SUBJECT: COMANCHE PEAK STEAM ELECTRIC STATION, UNITS 1 AND 2 - AMENDMENT
NOS. 52 AND 38 TO FACILITY OPERATING LICENSE NOS. NPF-87 AND NPF-89
(TAC NOS. M96244 AND M96245)

TEXAS UTILITIES ELECTRIC COMPANY
COMANCHE PEAK STEAM ELECTRIC STATION, UNIT 1
DOCKET NO. 50-445
AMENDMENT TO FACILITY OPERATING LICENSE

ATTACHMENT TO LICENSE AMENDMENT NOS. 52 AND 38

SAFETY EVALUATION BY THE OFFICE OF NUCLEAR REACTOR REGULATION
RELATED TO AMENDMENT NOS. 52 AND 38 TO
FACILITY OPERATING LICENSE NOS. NPF-87 AND NPF-89
TEXAS UTILITIES ELECTRIC COMPANY
COMANCHE PEAK STEAM ELECTRIC STATION, UNITS 1 AND 2
DOCKET NOS. 50-445 AND 50-446

FIGURE 2.1-1a

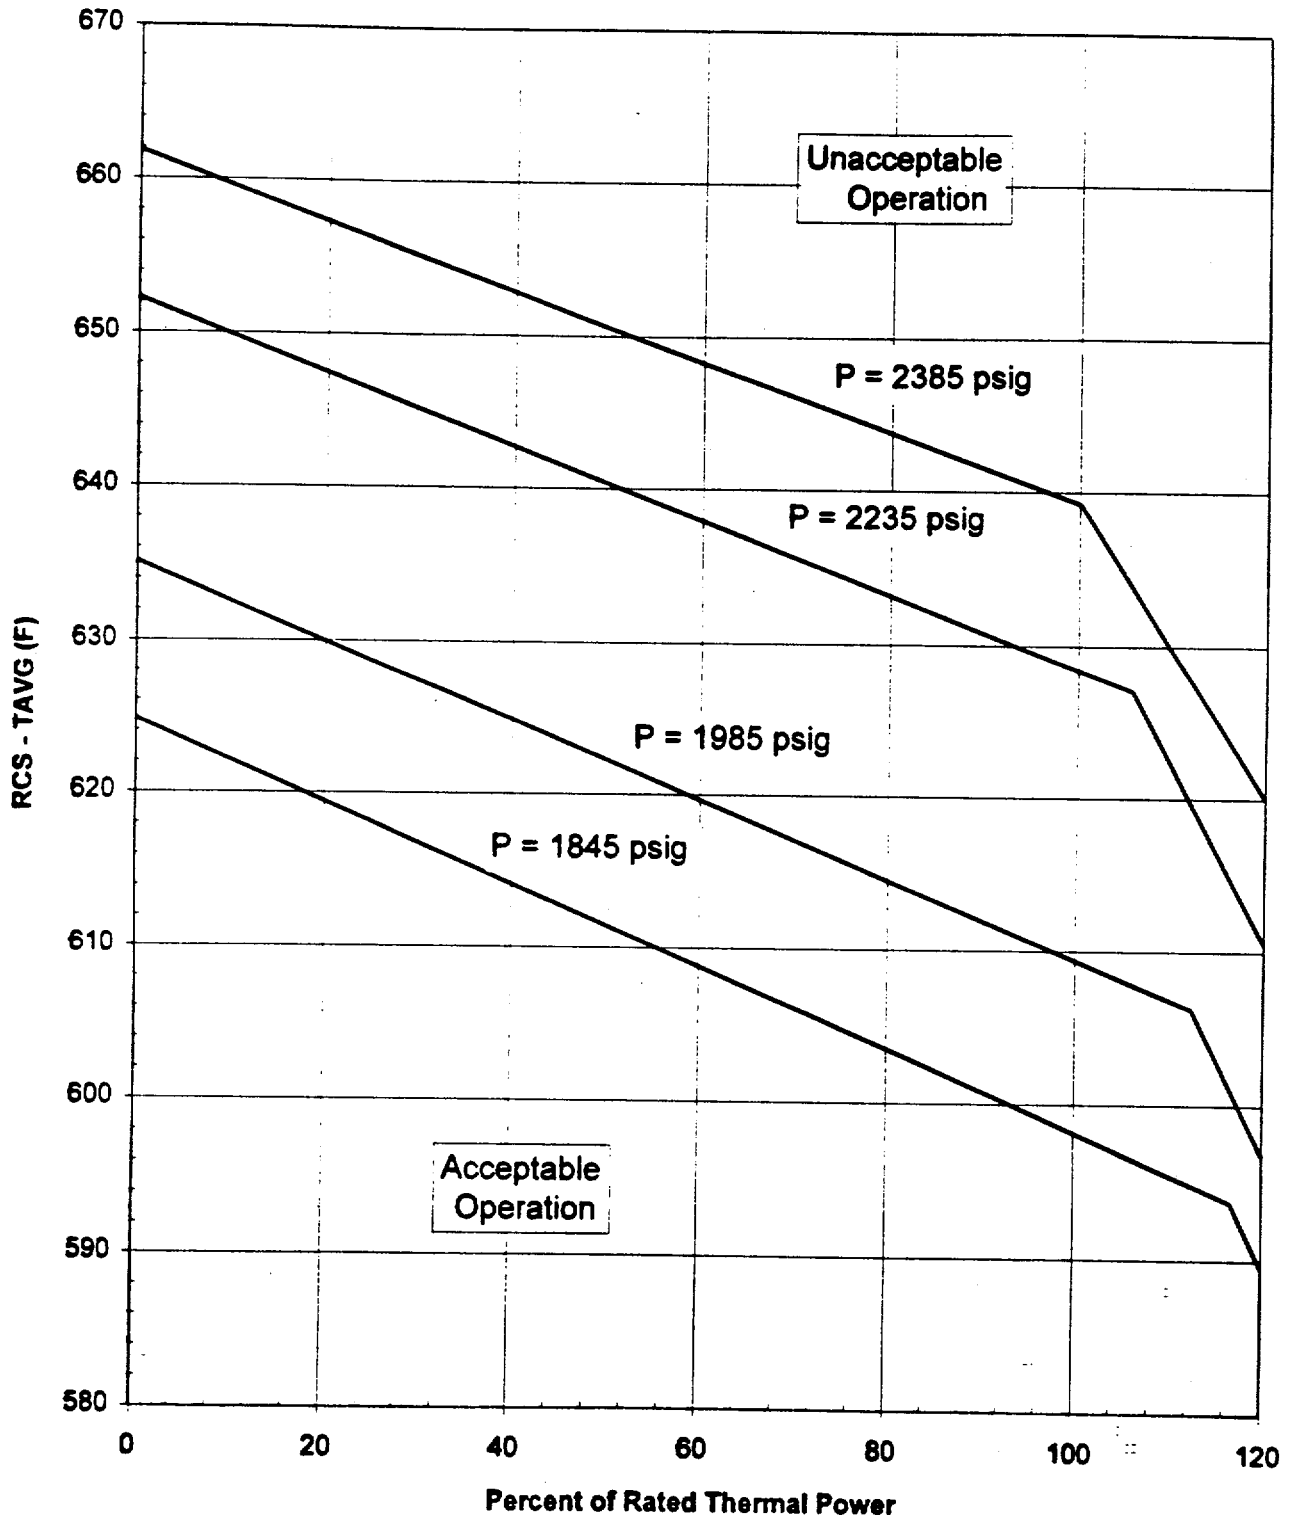
These amendments revise core safety limit curves (TS Figure 2.1-1a) and new N-16 setpoint values and parameters (TS Table 2.1-1) for Unit 1, and reference to topical report RXE-95-001-P as an approved methodology for small break loss of coolant accident (LOCA) analysis for Units 1 and 2.

Based on analyses of the core configuration for CPSES, Unit 1, Cycle 6, TU Electric has determined that revised core safety limit curves and overtemperature N-16 reactor trip setpoints are required. The core safety limits are the loci of points of thermal power, reactor coolant system (RCS) pressure and average temperature below which either the calculated departure from nucleate boiling ratio (DNBR) is no less than the safety limit value, or the average enthalpy at the vessel exit is less than the enthalpy of saturated liquid. The overtemperature N-16 reactor trip setpoint is calculated such that a reactor trip will be initiated before the core safety limits are exceeded.

The transient most affected by the change in the overtemperature N-16 trip setpoint is the control rod withdrawal event from full power conditions. TU Electric reanalyzed this event using NRC-approved methodologies, as specified in TS 6.9.1.6b, and the revised overtemperature N-16 trip setpoint. The event was shown to terminate before a departure from nucleate boiling (DNB) condition was reached. Since this limiting event, as well as the analyses of the revised core safety limits and the overtemperature N-16 trip setpoint, was performed in accordance with the NRC-approved methodologies listed in TS 6.9.1.6b, and satisfied all relevant acceptance criteria, the proposed TS changes to the core safety limits and the overtemperature N-16 trip are acceptable.

The staff has reviewed the proposed changes to the CPSES, Units 1 and 2 TS to reflect revised core safety limit curves (TS Figure 2.1-1a), new N-16 setpoint values and parameters (TS Table 2.1-1), and the inclusion of RXE-95-001-P as an approved methodology for small break LOCA analysis. Based on the NRC evaluation given above, the proposed changes are acceptable.
